SERVICE PROCEDURE

G-07514
February 2008

SUBJECT: SAFETY RECALL (U.S.)
BATTERY CABLES on certain MXT Models built
5/20/2006 thru 4/23/2007

Figure 2.

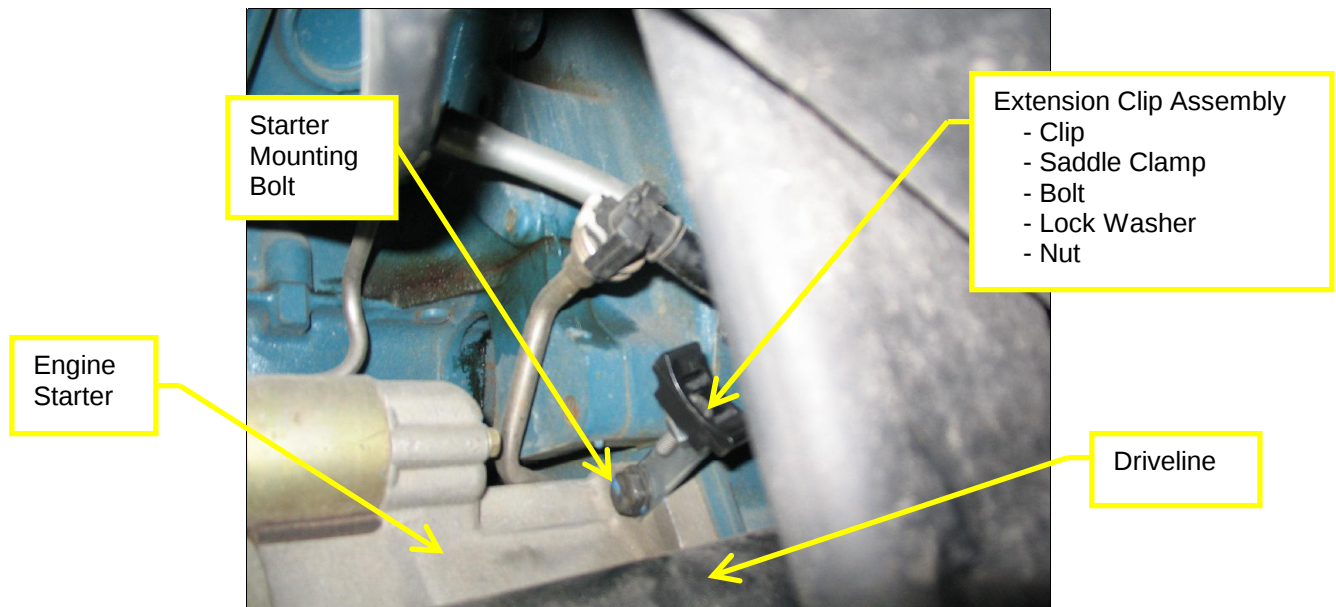
7. Install extension clip assembly onto the engine starter using the existing starter mounting bolt as shown in Figure 2. The parts needed are: 308578C1 extension clip, 2041341C1 saddle clamp, 25483R1 bolt, 120380 lock washer, and 25519R1 nut.

Figure 3.

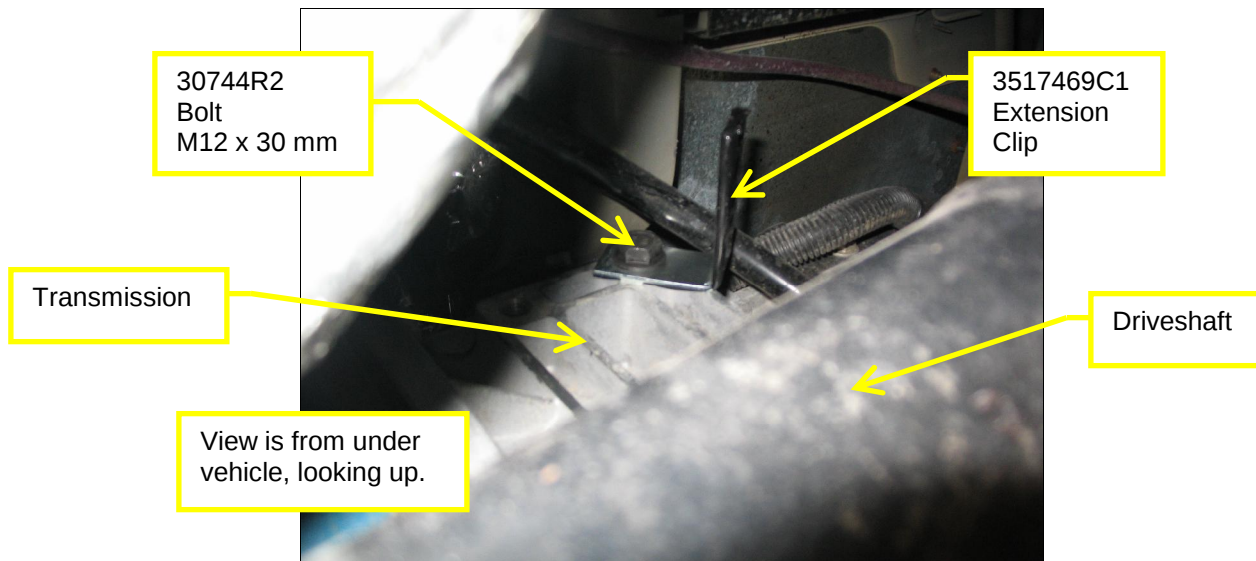
8. Install extension clip assembly onto the upper transmission mounting pad as shown in Figure 3. The parts needed are 3517469C1 extension clip and 30744R2 bolt.

Figure 4.

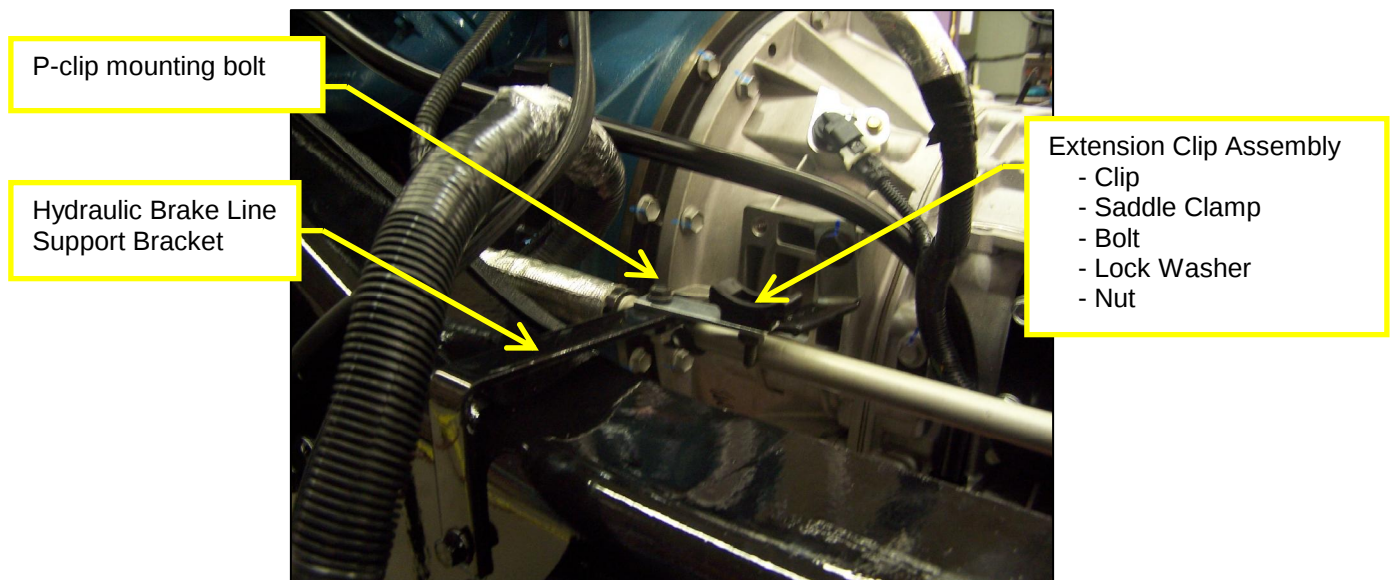
9. Install extension clip assembly onto the hydraulic brake line support bracket using existing p-clip mounting bolt as shown in Figure 4. The parts needed are: 432013C1 extension clip, 2041341C1 saddle clamp, 25483R1 bolt, 120380 lock washer, and 25519R1 nut.

Figure 5.

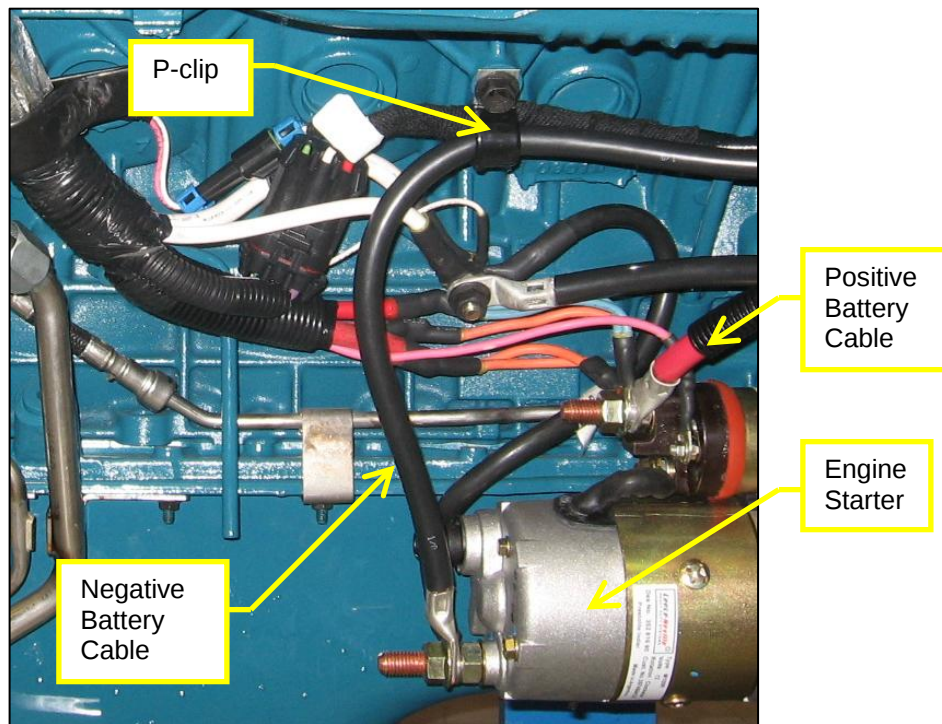
10. Route the negative battery cable thru the p-clip on the side of the engine as shown in Figure 5.

Figure 6.

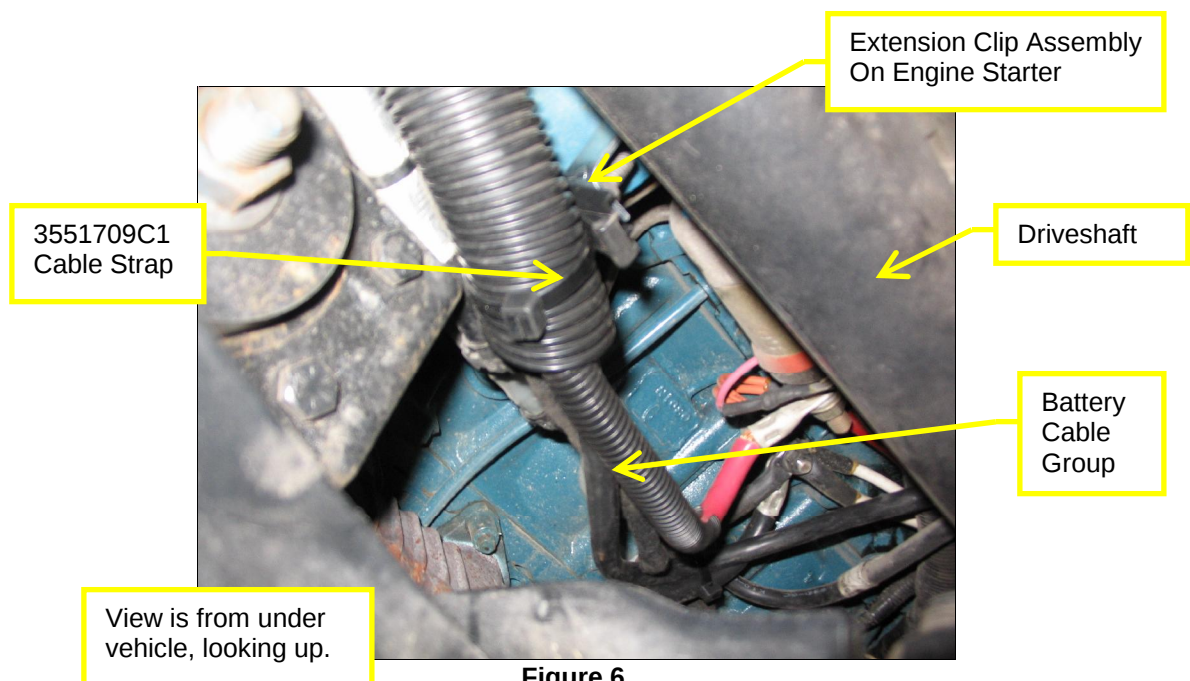
11. Route the positive cable, negative cable, and clean power to ground cable together at the extension clip assembly installed on the engine starter using 3551709C1 cable strap as shown in Figure 6.

Figure 7.

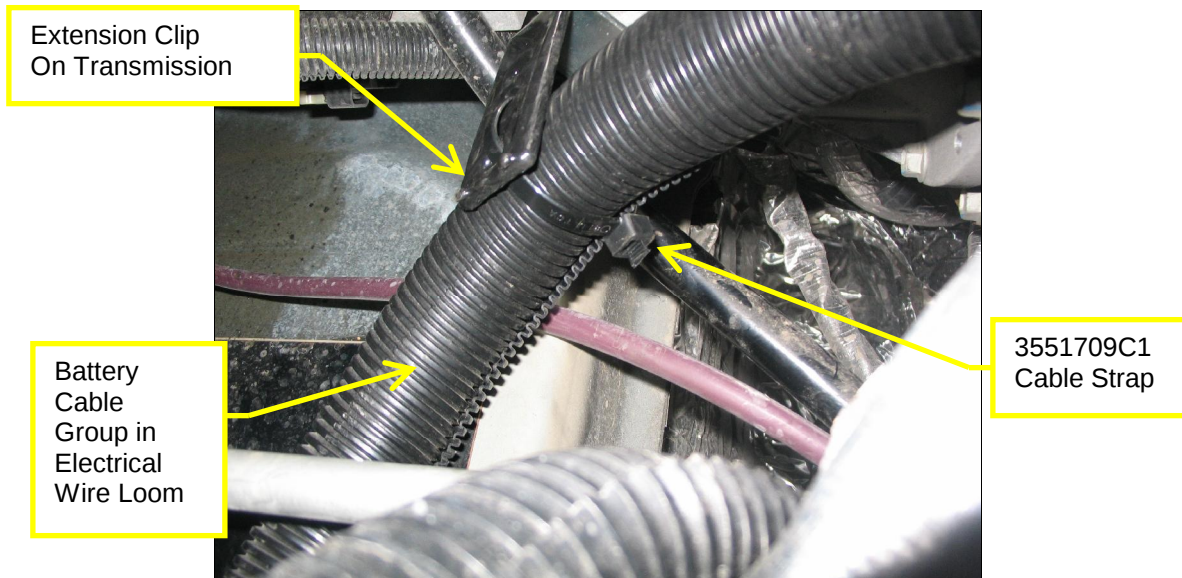
12. Route the battery cable group to the battery box using the newly installed extension clip assemblies as shown in Figures 7, 8, and 9. The parts needed are tie straps 3551709C1 and 3516934C1.
